City of Santa Fe, New Mexico

memo

2026-011768-HDRB, 801 Old Santa Fe Trail Unit A, Downtown & Eastside Historic District, Significant, Santa Fe Permits/Jennifer Salimbene, agent for Stuart Cohen, owner, proposes to replace windows. An exception is requested to 14-5.2(D)(5)(1)(a) for replacing historic windows on primary facades.

Figure 4: Window Schedule

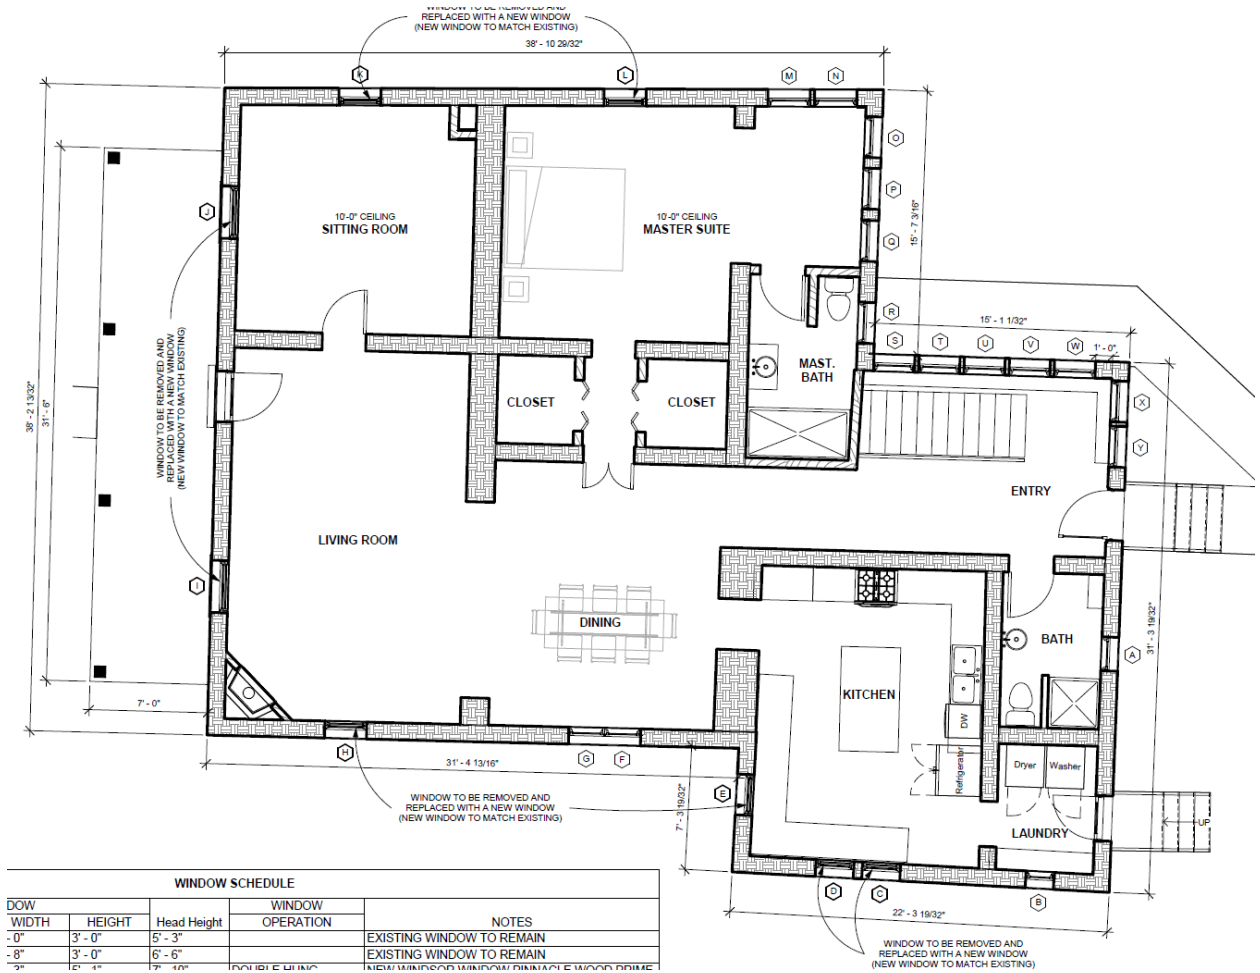
- 1) Replacement of eight windows. The new window frame will overlap the old window frame, allowing for the removal of the old sash, and leaving the historic frames to remain in place. Window replacement will be in-kind, with double-hung Windsor window pinnacle wood prime windows. An exception is requested to 14-5.2(D)(5)(1)(a) for replacing historic windows on primary facades.
 - a. Replacement of windows C, D, E (west-facing), and H on the south elevation. Windows are currently single-lite windows. Window C has a historic frame, while the components of the window were replaced between 1988 and 1994 and are not historic. Window D is a three-over-four and is

not historic. Window E has a historic frame, but the sashes were replaced in 1988. Window H is historic and is unsatisfactorily rotted beyond repair. The historic frames of windows C and E will remain with the new window sitting in the historic frame.

- b. Replacement of windows I and J on the west elevation. Windows are currently two over two. Window I has a historic frame, but the divided lite pattern does not match the residence and is not a historic window. Window J is not historic.
- c. Replacement of windows K and L on the north elevation. Windows are currently single-lite windows and are not historic.
- d. Repair as needed windows A, B, F, G, and M through Y. These windows will not be replaced.

Staff Response: Staff finds that this criterion is met. The only window that is fully historic is window E, which is rotted beyond repair. Windows C, E, and I each have historic frames that will not be changed out. Therefore, the impact on the district will be minimal.

Staff Response: Staff finds that this criterion is met. The one historic window will cause structural damage if not addressed.

Staff finds that the exception criteria have been met and recommends approval of the exception to section 14-5.2(D)(5)(1)(a) for replacing historic windows on primary facades. Otherwise, staff recommend approval of the other elements of the application as they comply with 14-5.2(D) General Design Standards for all Historic Districts, and 14-5.2(E) Downtown and Eastside Historic District Design Standards.
